RE: Data Response, Set 2A
Ivanpah Solar Electric Generating System (07-AFC-5)

Ivanpah Solar Electric Generating System (ISEGS)

Data Response, Set 2A

FIGURE 3-9
Sheet 9 of 18
Ephemeral Washes Map
Ivanpah Solar Generating System

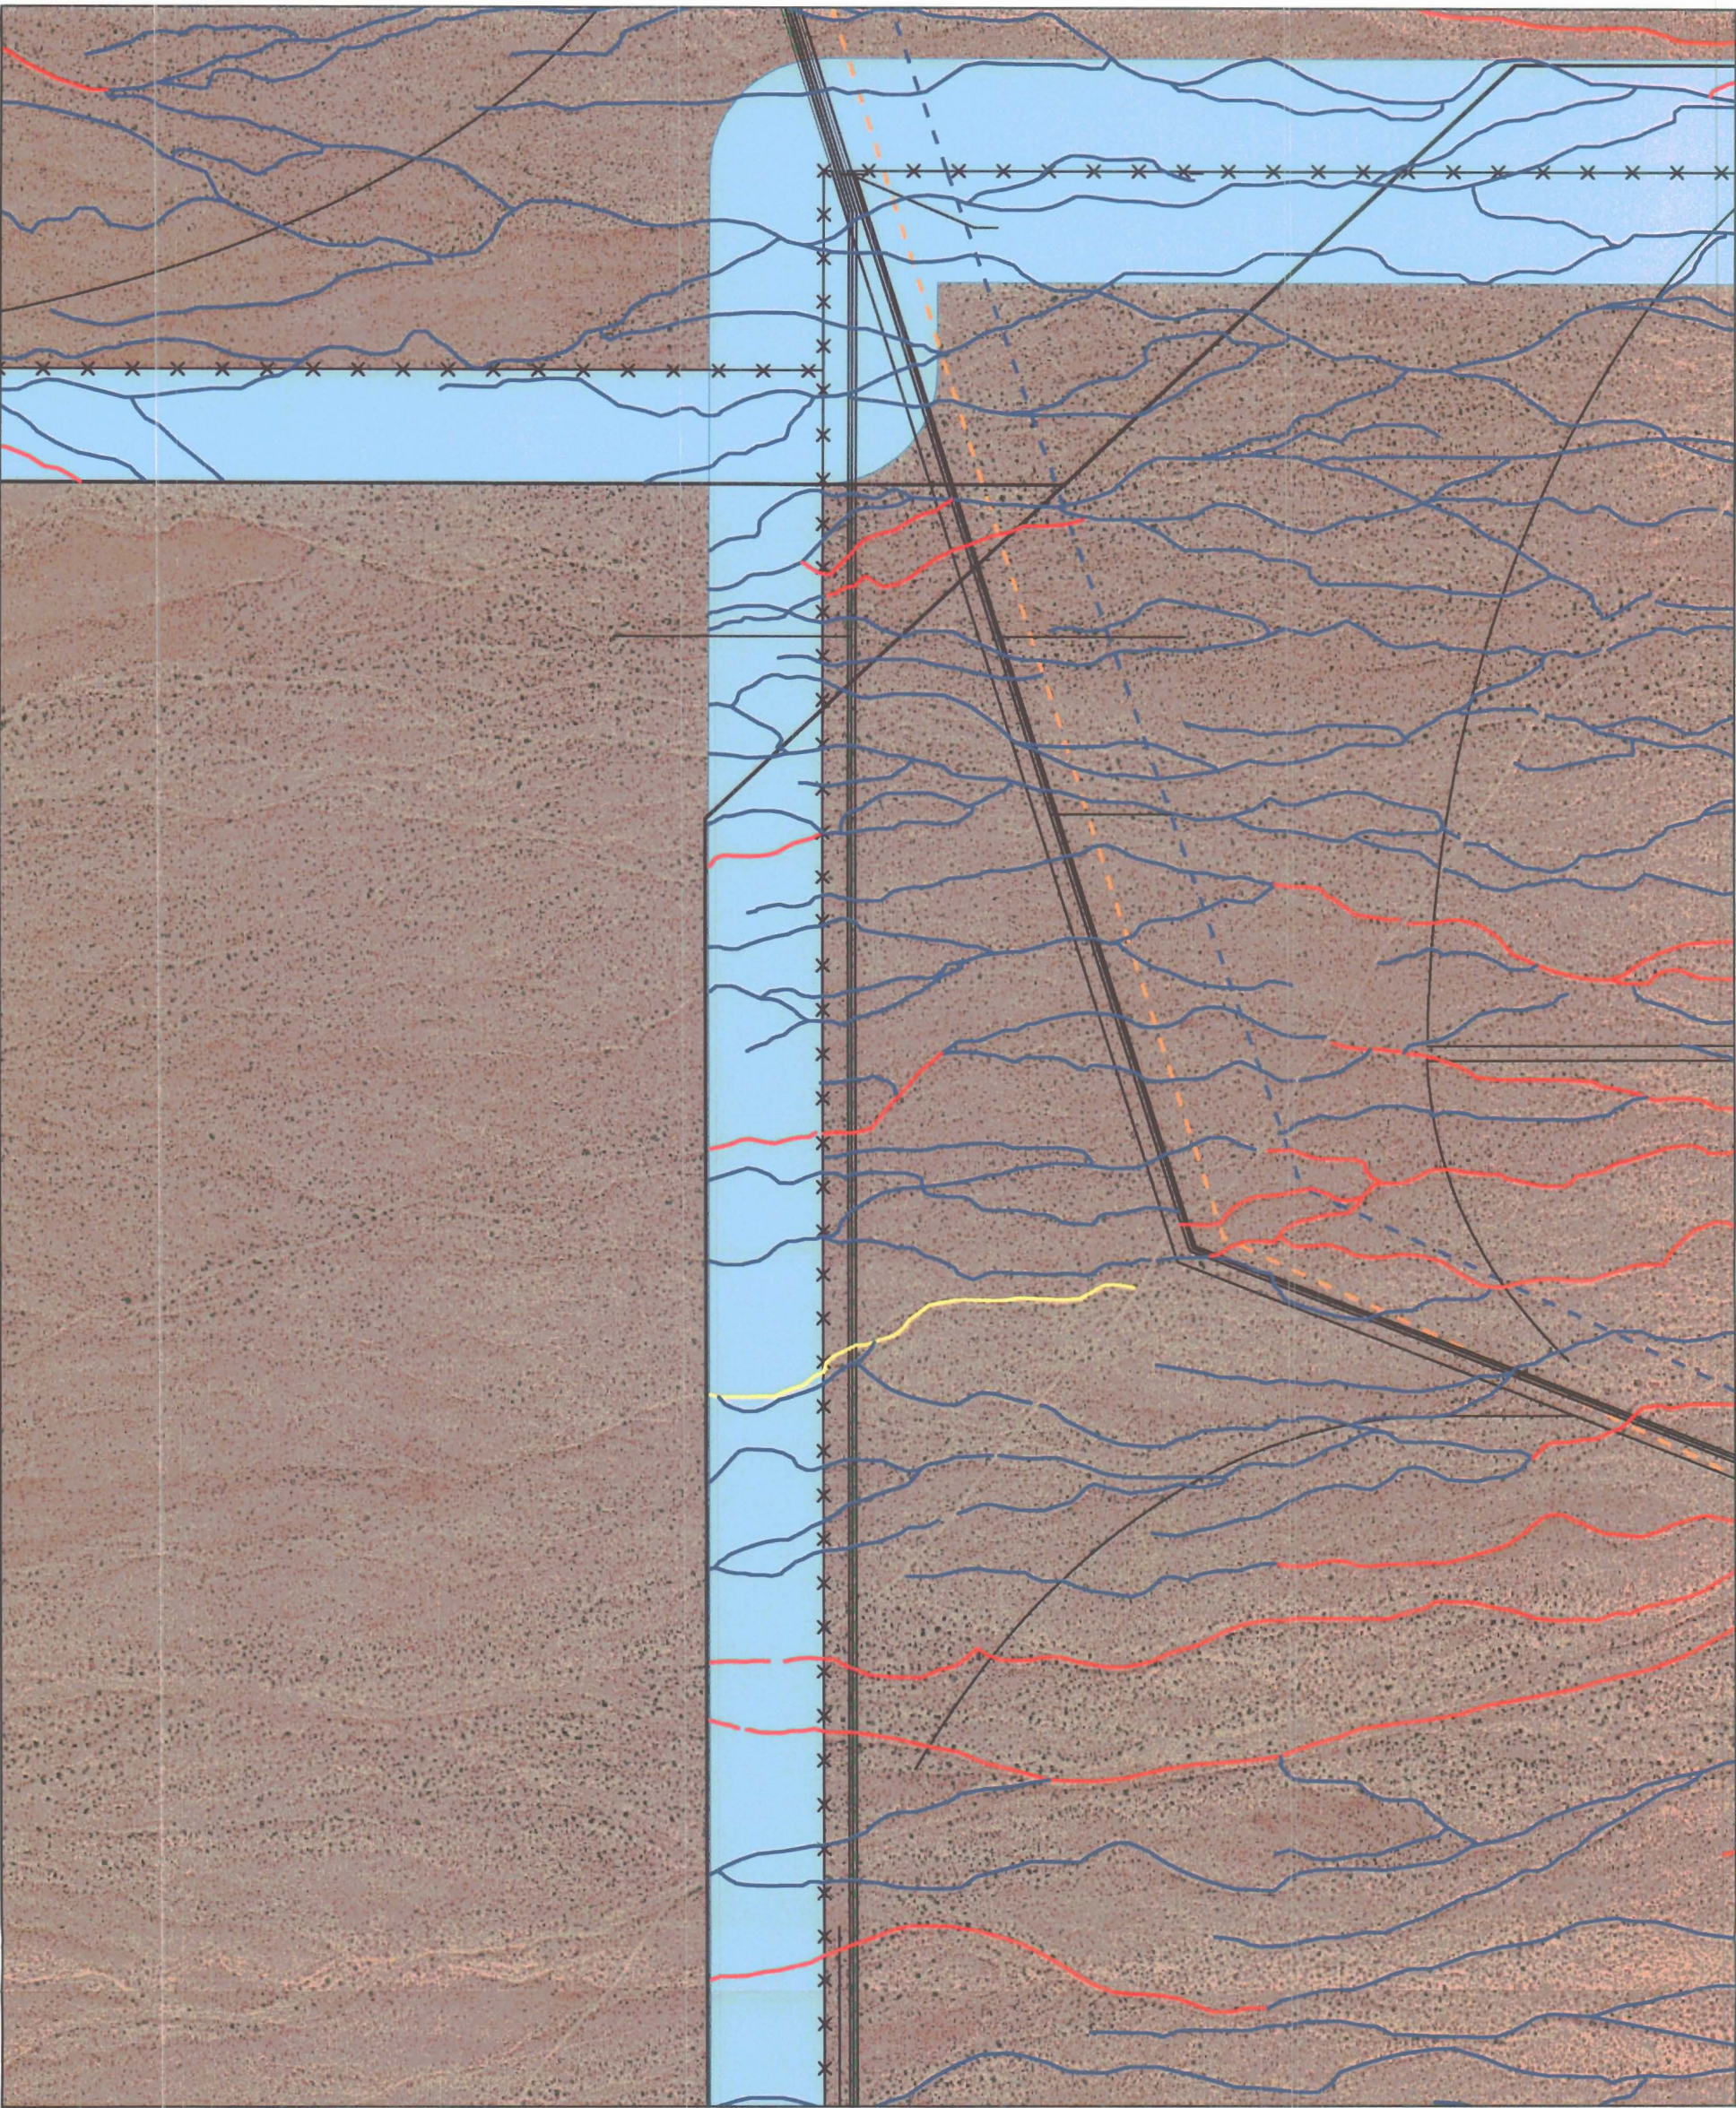
- f. Figure 3-9 of the draft DESCP has errors in the form of seemingly random lines on the figure. It appears to be the result of a printing malfunction or error in the graphic computer file. Please correct this figure.

Response: A revised printout of Figure 3-9 is provided at the end of this section.
